vermont Yankee Nuclear Power Corporation, Docket No. 50-271, Vermont Yankee Nuclear Power Station, Vernon, Vermont

Brief description of amendment: The amendment revises the Technical specifications to permit extended reactor operation with one recirculation loop out of service.

Amendment No.: 94

AMENDMENT TO FACILITY OPERATING LICENSE

Figure 2.1-1

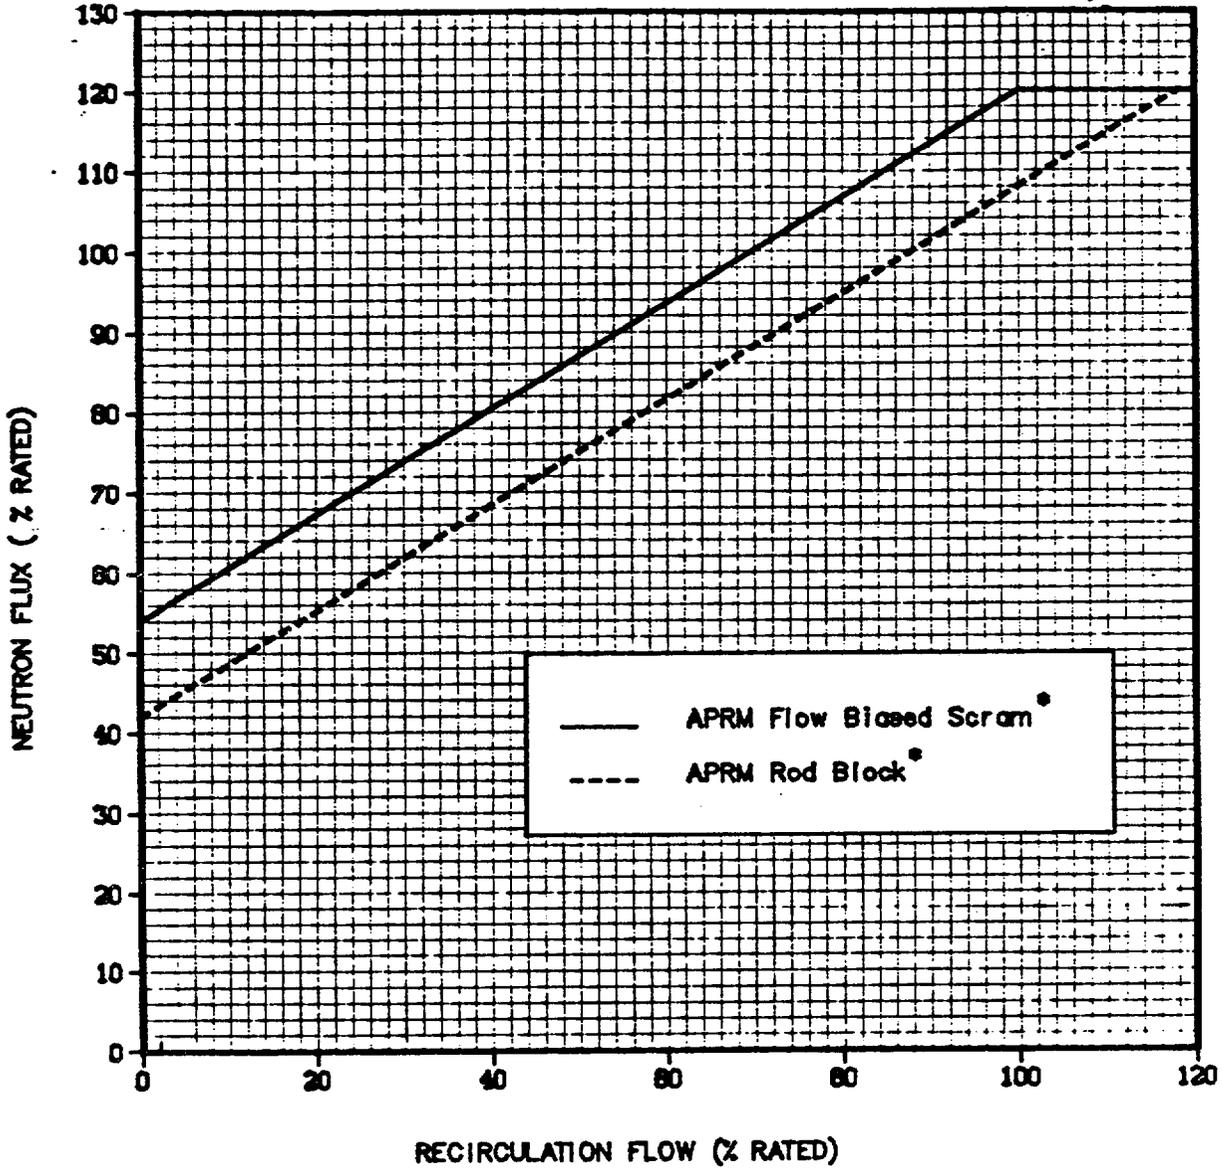
- (2) 2.1.A, 2.1.B, Figure 2.1-1 and Basis 2.1: The equation for the APRM Flux Scram setting and APRM Rod Block trip setting have an added delta W term to account for the difference between TLO and SLO drive flow at the same core flow. This has been previously discussed and is acceptable. There are also some administrative page changes to accommodate the technical changes.

• For single loop operation, the APRM Scram and Rod Block settings are adjusted according to Technical Specifications 2.1.A.1.a and 2.1.B.1

Figure 3.6.4

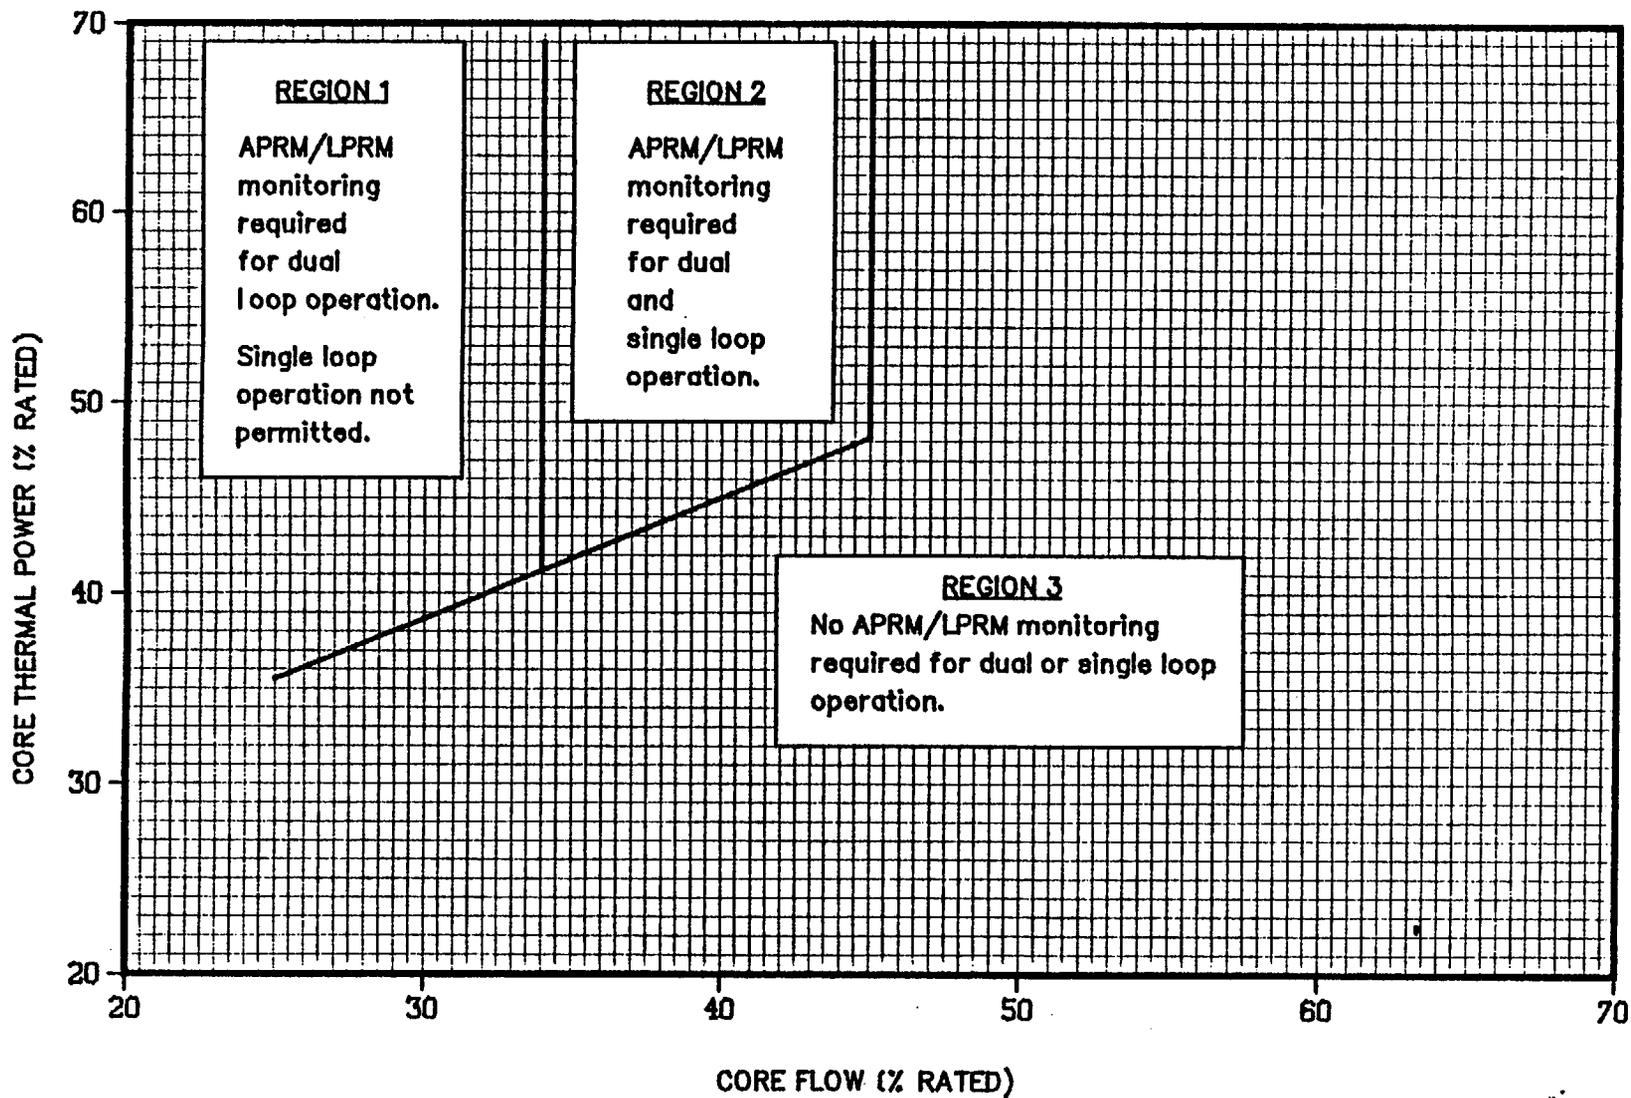
- (4) 3/4.6.G, H and J, Figure 3.6.4 and Bases 3/4.6.G, H and J: These changes and additions provide for and describe the TLO and SLO surveillance regions in the power-flow map, the nature of the APRM-LPRM surveillance, baseline and operation information required, and the levels and time frames for action in providing this surveillance and acting on it. Manual flow control is required for SLO. As previously discussed these requirements provide a satisfactory representation of the recommendation of SIL-380 and the staff generic position and previous approvals, and are acceptable. There are also some administrative page changes and a change relating to previously approved Amendment 92.

- c. With one recirculation pump not in operation, core thermal power greater than the limit specified in Figure 3.6.4, and core flow less than 34% of rated (Region 1 of Figure 3.6.4), initiate action within 15 minutes of entering this region such that operation is outside this region within 2 hours.

- b. If baseline APRM and LPRM<sup>(1)</sup> neutron flux noise levels have not been established since the last core refueling, initiate action within 15 minutes of entering these regions (Regions 1 and 2 of Figure 3.6.4) such that operation is outside these regions within 2 hours.
